***Public consultation for the design of the TERRE  
(Trans European Replacement Reserves Exchange)***

**23<sup>rd</sup> of June 2016 (Project Answers)**

### **Unshared Bids**

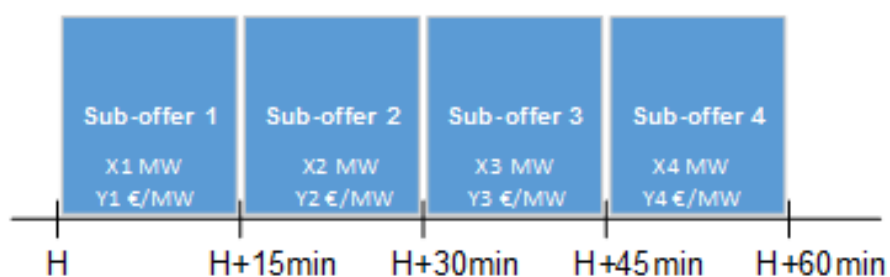
***What is TSO's necessity for Unshared Bids? Will BSPs be compensated for their Unshared Bids? Will Stakeholders be informed (live?) when their bids are marked Unshared? Stakeholders requested further details on the topic.***

The ability to unshare bids from the TERRE platform will be used when the TSO has a requirement to keep some replacement reserves for their own use. This possibility is also offered in the GL EB. Nevertheless, a local consultation, in each Market Balancing Area, on this topic will be organized and the validation of NRA will be necessary on some features (e.g. Maximum volume of unshared bids, etc.)
